Enclosed please find an application for authorization to inject water into the Roosevelt SWD #1, API No. 30-045-31448. This well will serve as a replacement to the proposed SWD well Roosevelt #1 API No. 30-045-26458 which failed to pass the pressure test requirements. We are requesting that the application be approved administratively. Please feel free to call me if you have any questions.

APPLICATION FOR AUTHORIZATION TO INJECT

WELL NAME & NUMBER: Roosevelt SWD #1

ROOSEVELT SWD #1

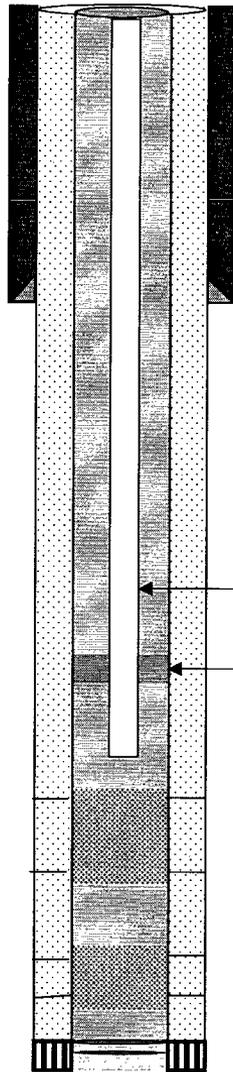
- This interval may include Monahoe - Should be 2799-2950 as per State App.

*CA - 2800 - 2950
P.L - 3720 - 3830*
